D.N.D.

SMALL HOUSE DESIGNS

PREPARED BY CENTRAL MORTGAGE & HOUSING CORPORATION

Preliminary Resume of D.N.D. House Designs

A/54/T

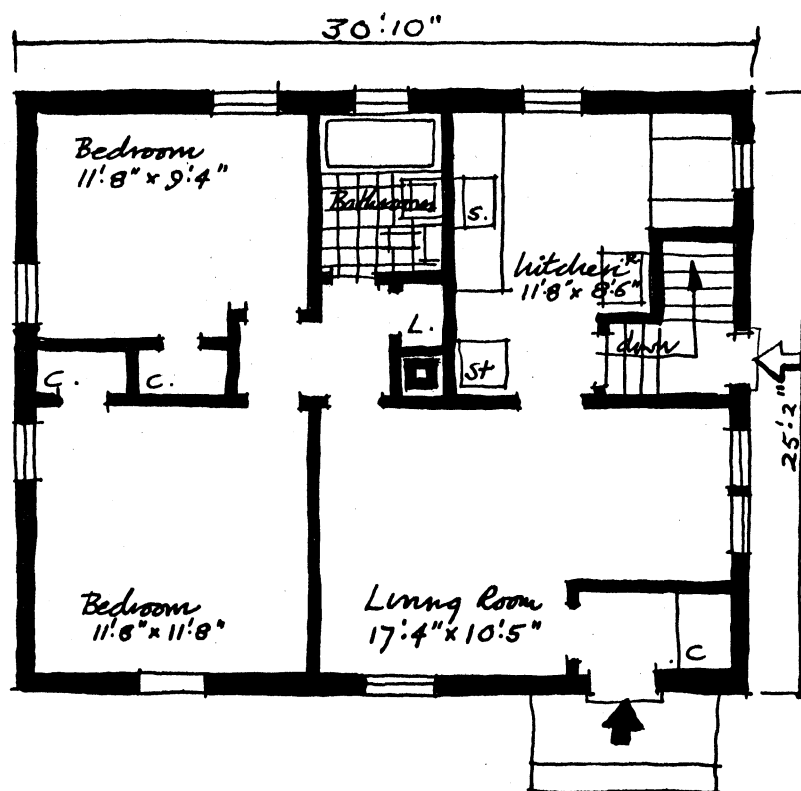
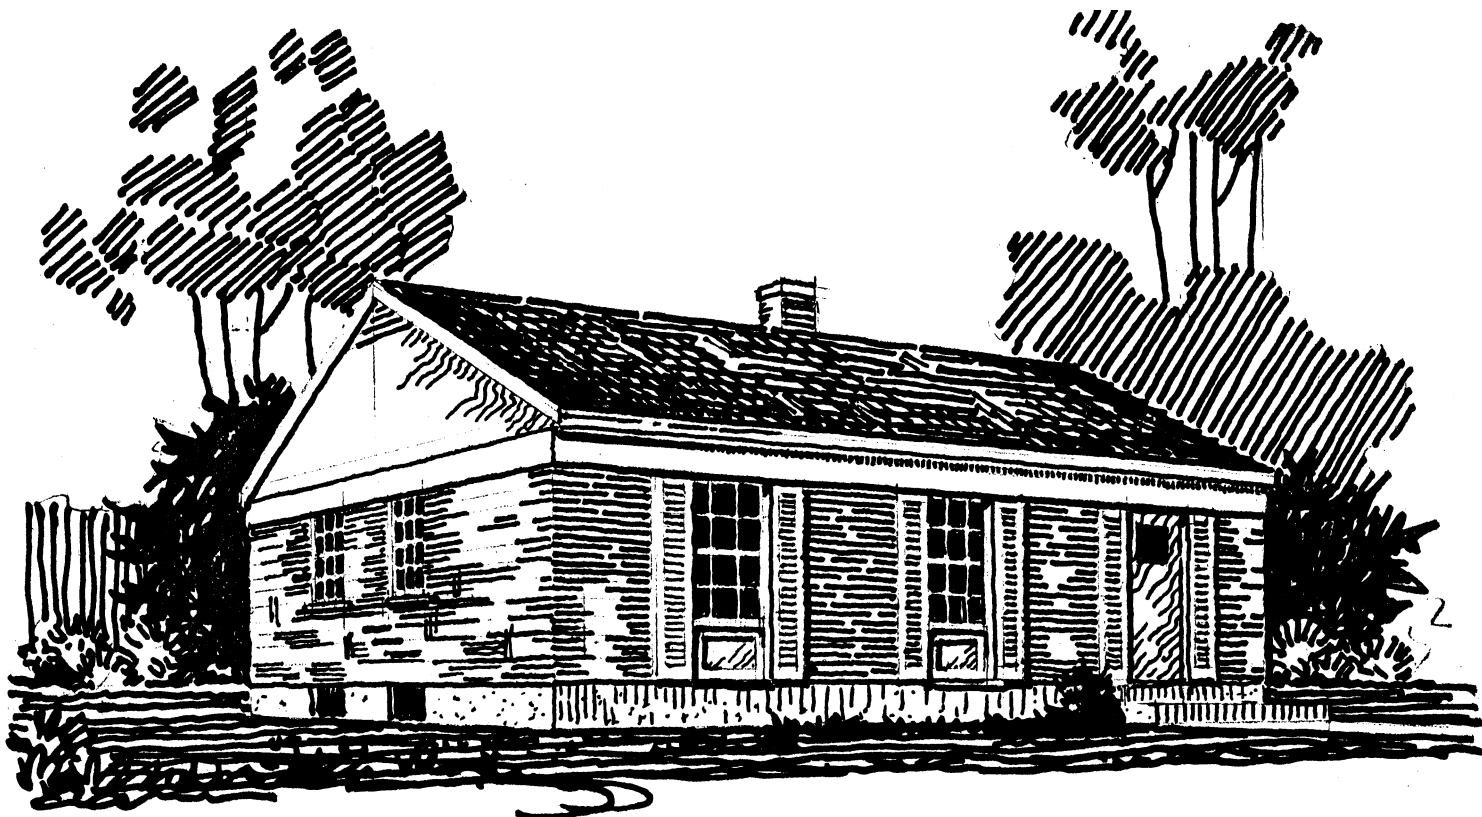
1. Add porch cover over front door.
2. Increase width of main entrance and vestibule doors to 3'-0" to permit easy access of furniture but preserve dining space.
3. D.N.D. accepts bathroom windows over bath.
4. D.N.D. accepts this house.

A/54/S

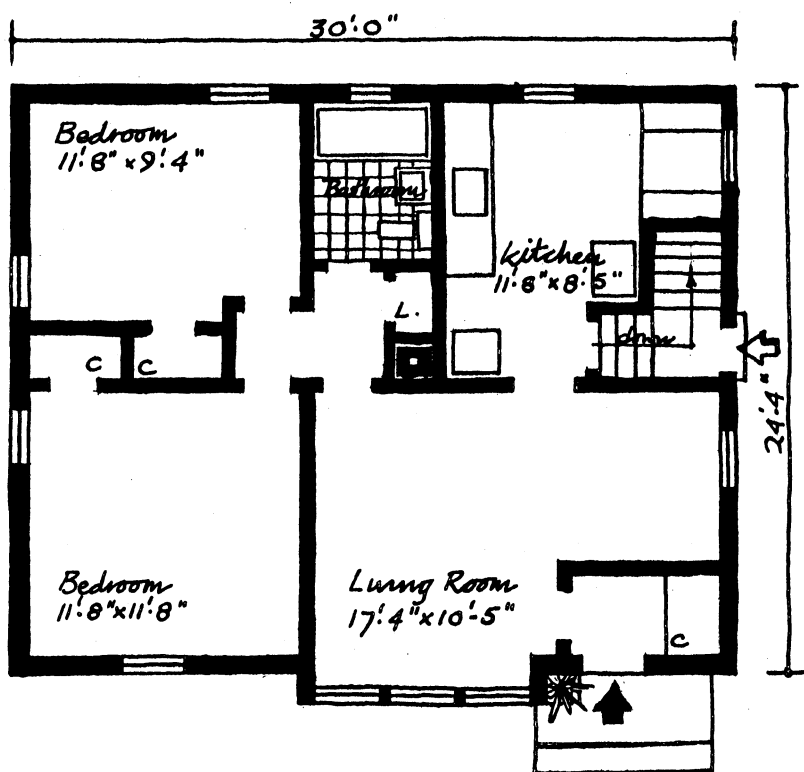
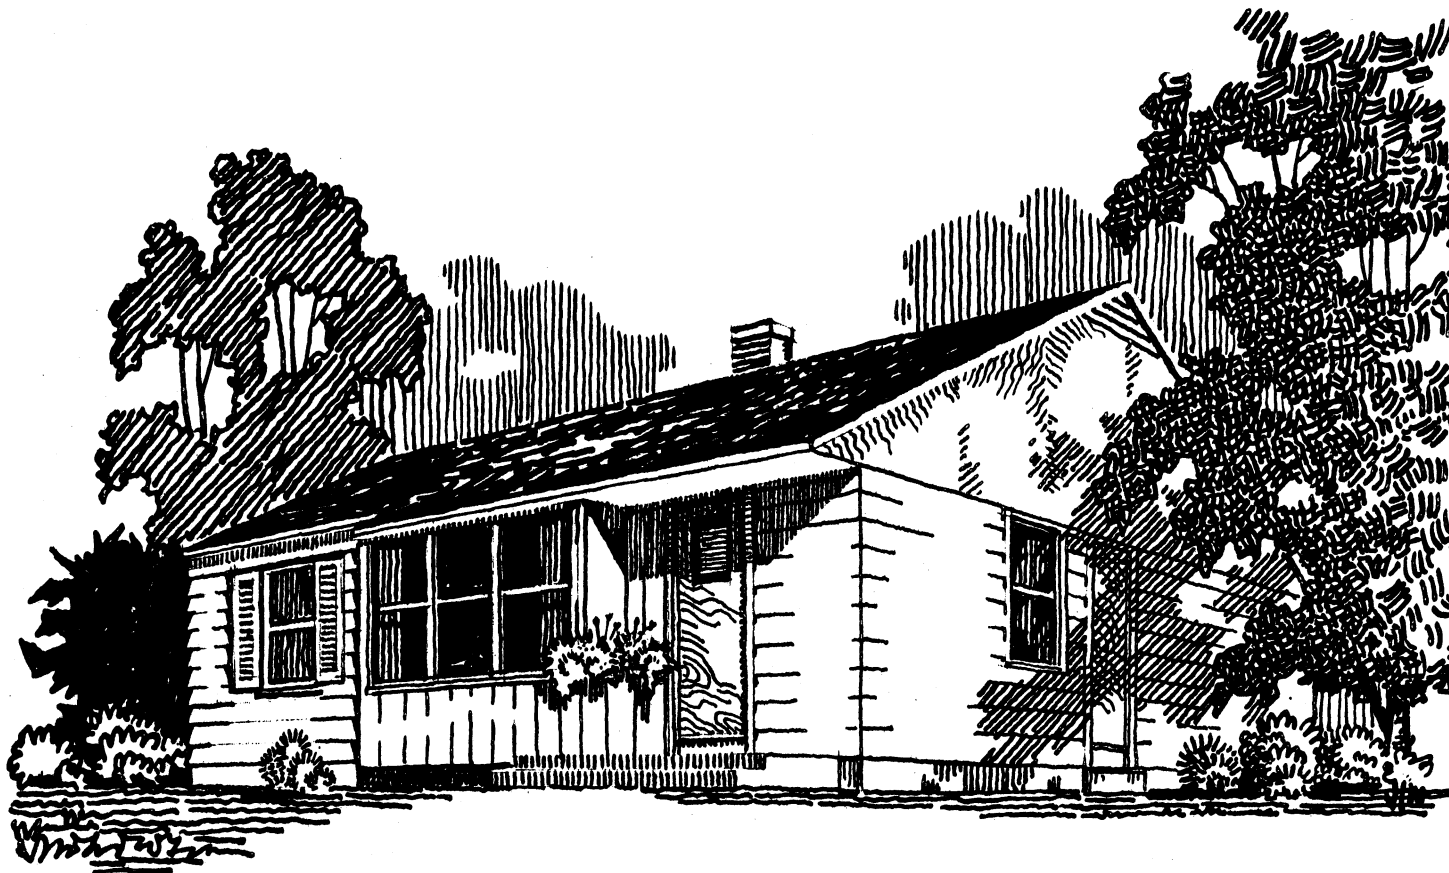
1. Same comments as for A/T.
2. Covered door satisfactory.

A/54/C

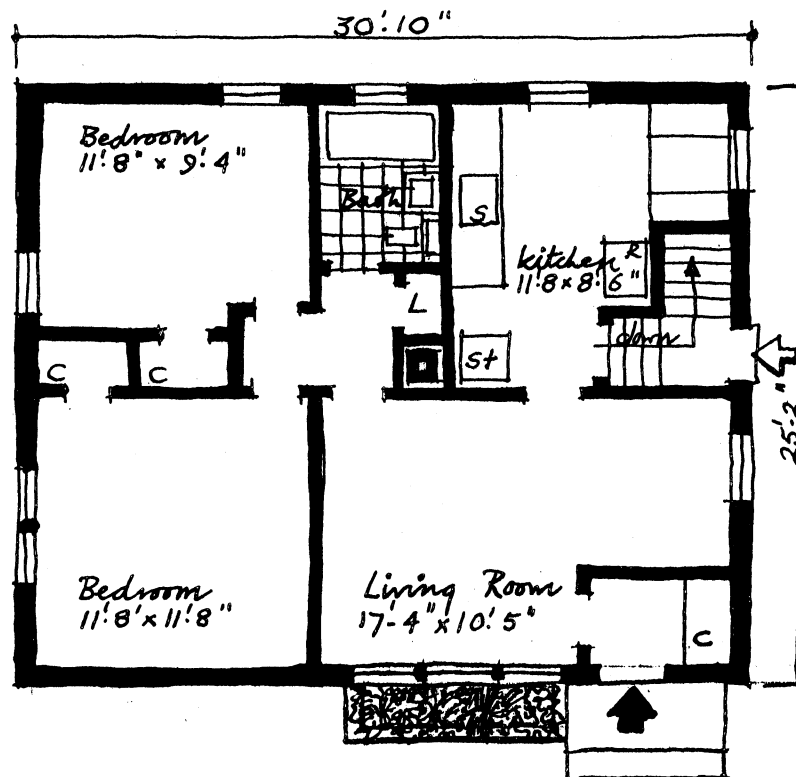
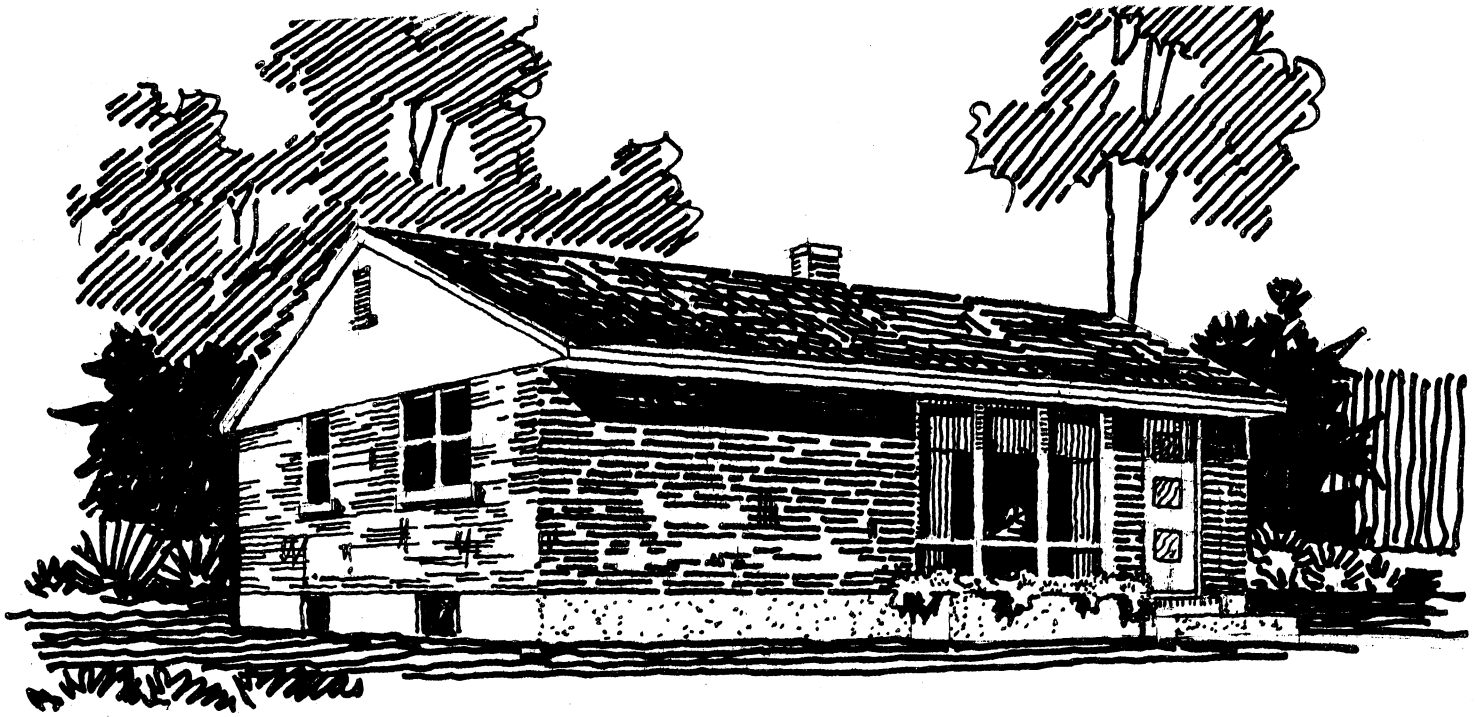
1. Same comments as for A/T.
2. Roof pitch to be made shallower and project over entrance for protection from weather.

B/54/T

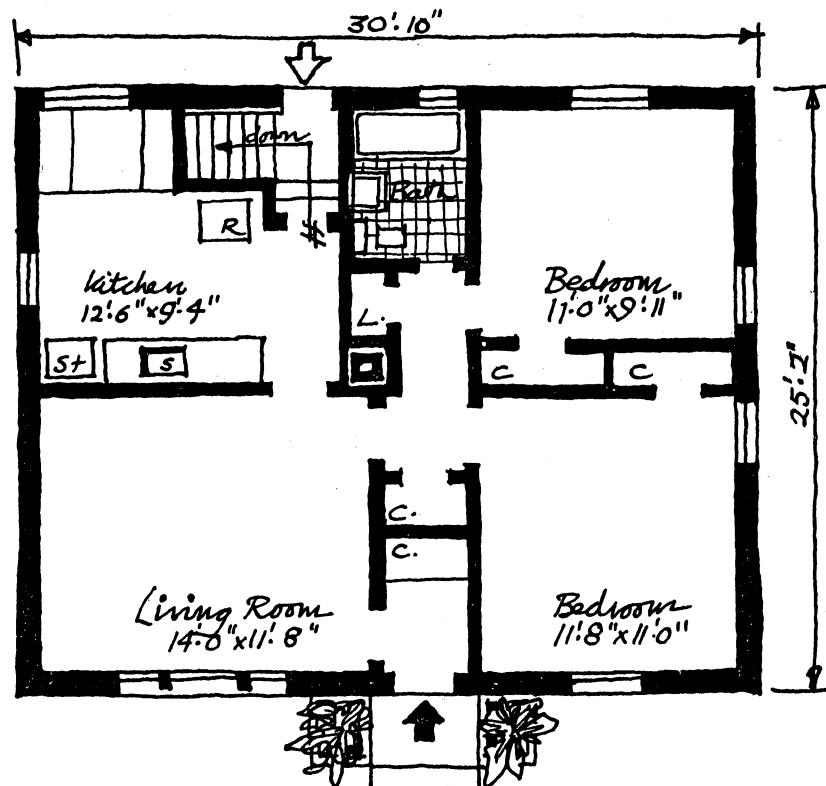
1. Acceptable with same comments as for A/T.
2. Recess front doorway for cover.

B/54/C

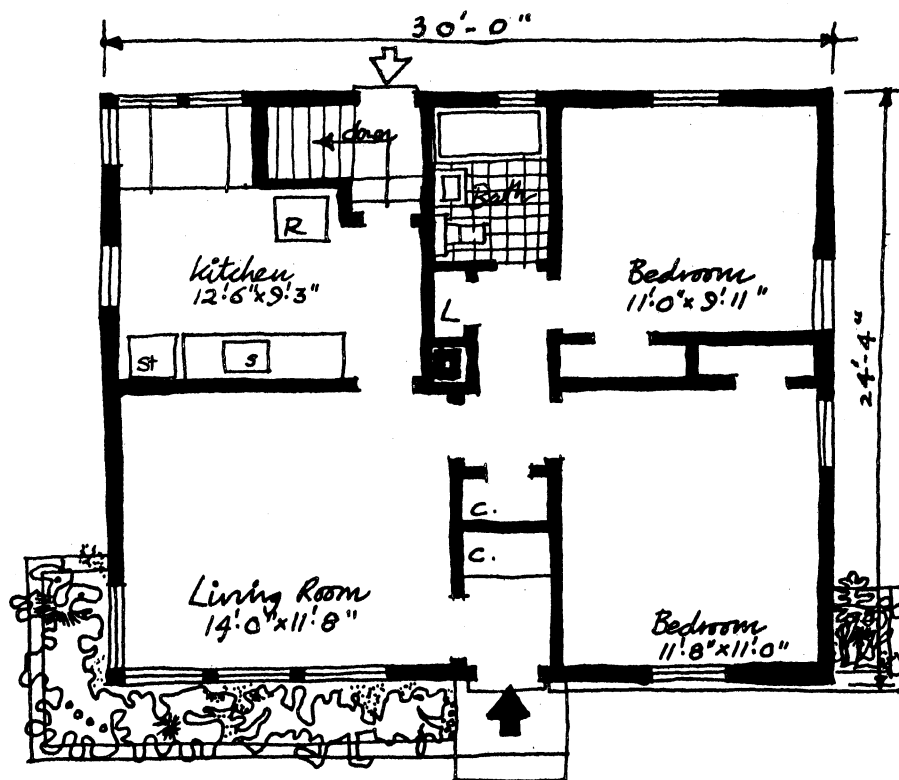
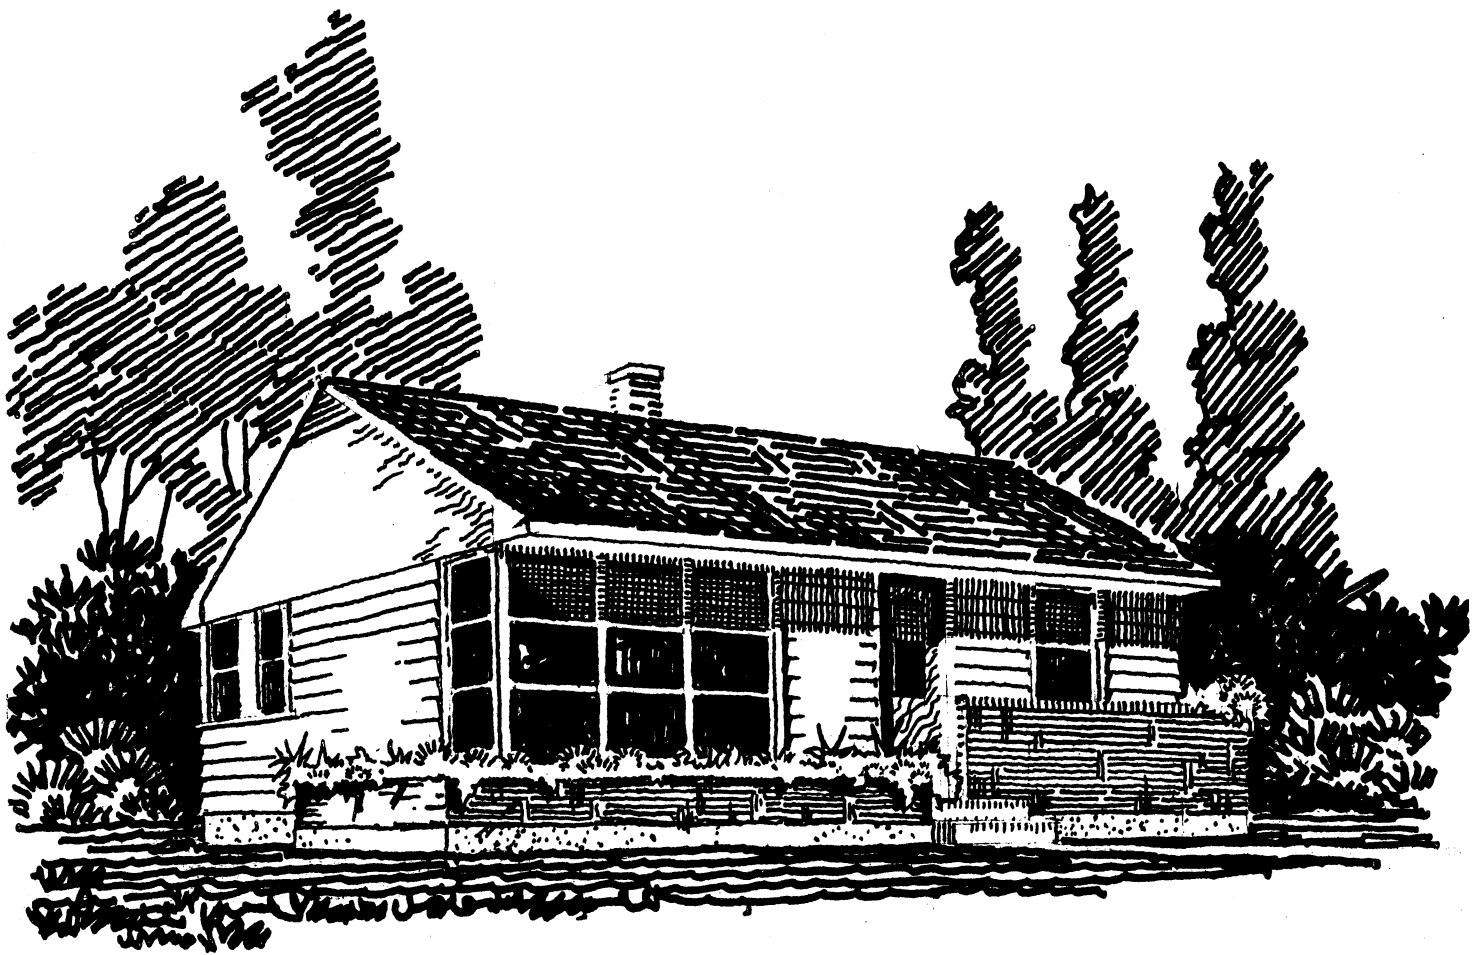
1. Recess doorway otherwise OK.

C/54/C

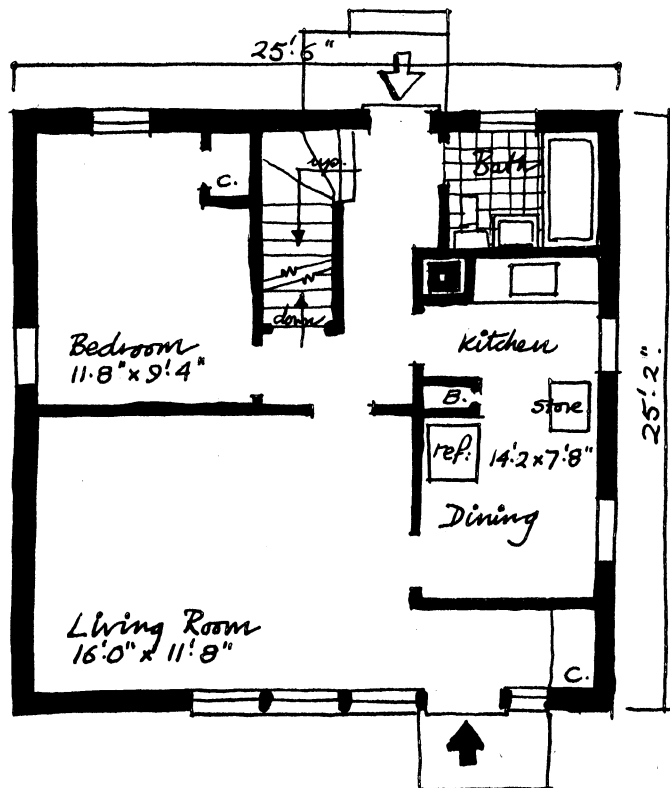
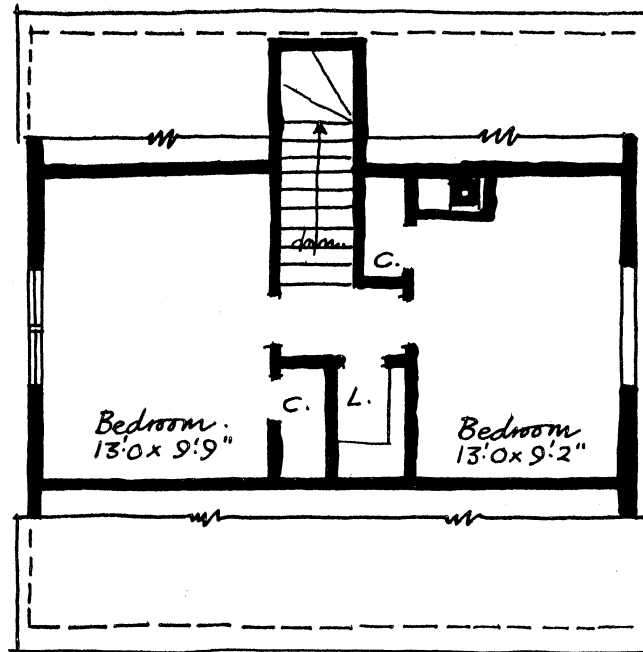
1. To be used with reservation along side
Class I, with brick veneer.

K/54/S

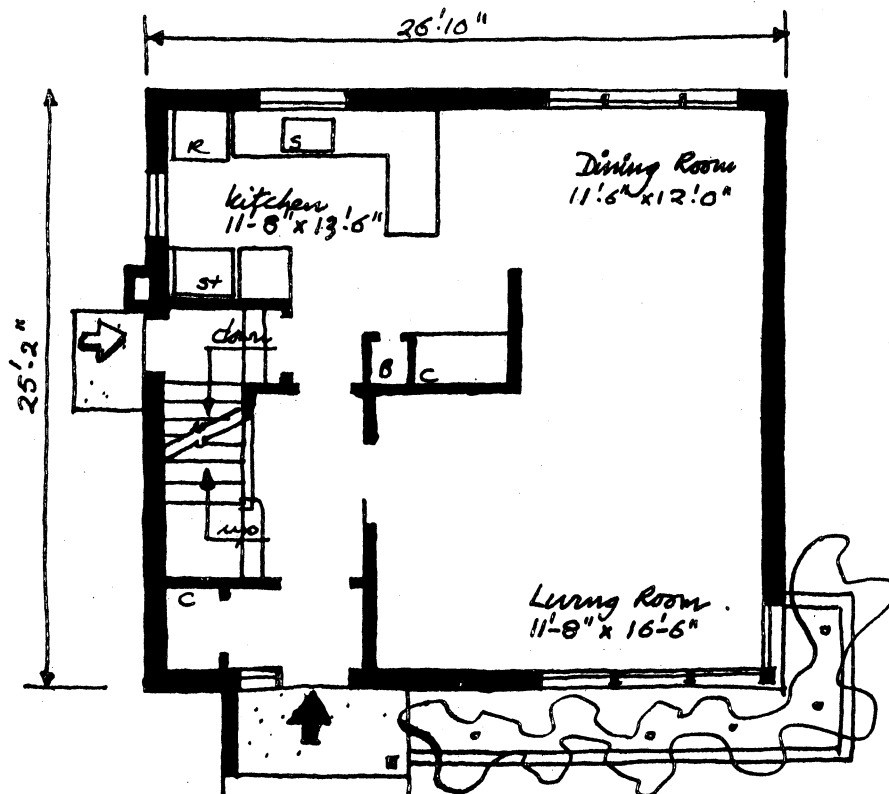
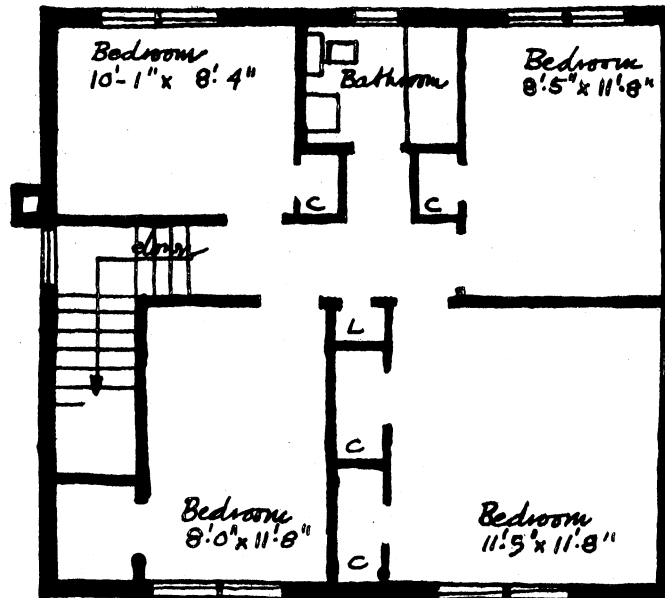
1. Top could be of stucco.
2. D.N.D. accepts this house.

K/54/C

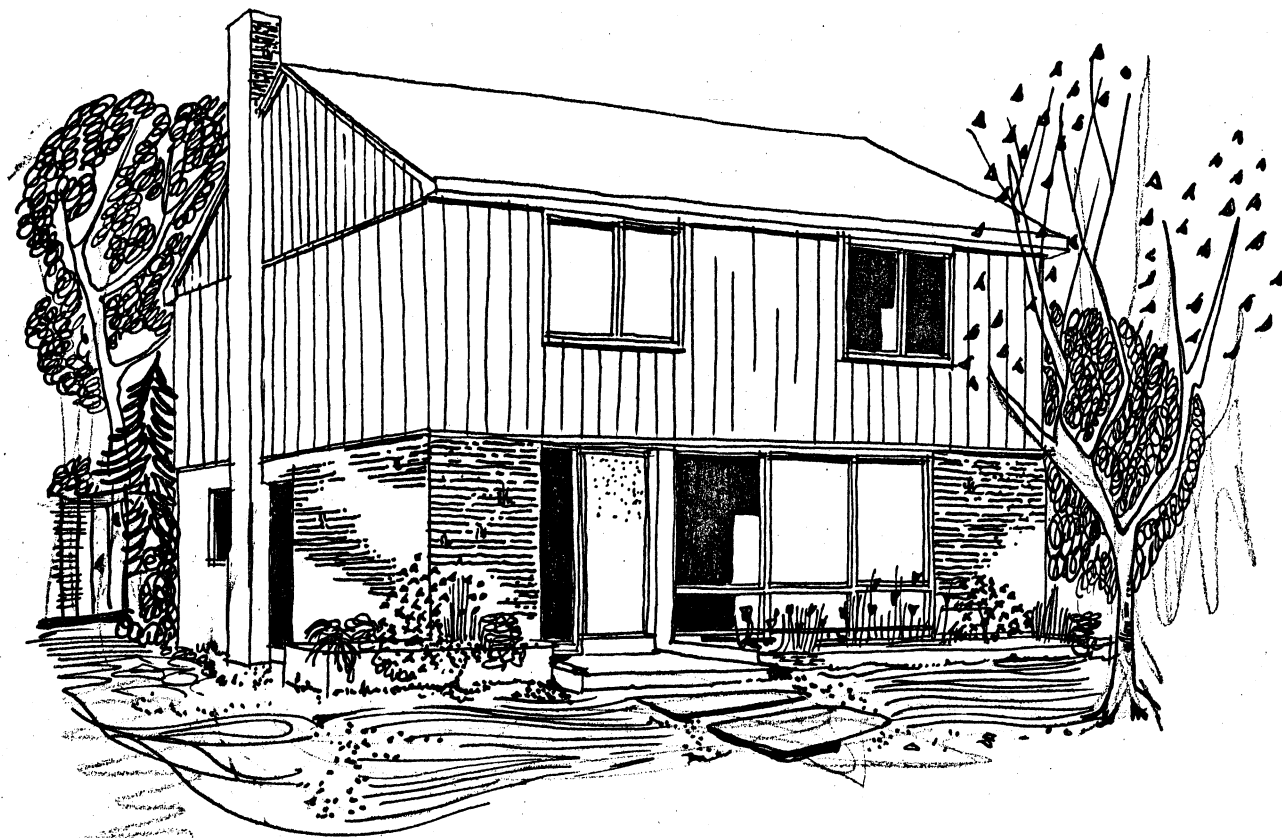
1. Provide cover over door.
2. Same comments as for K/S.
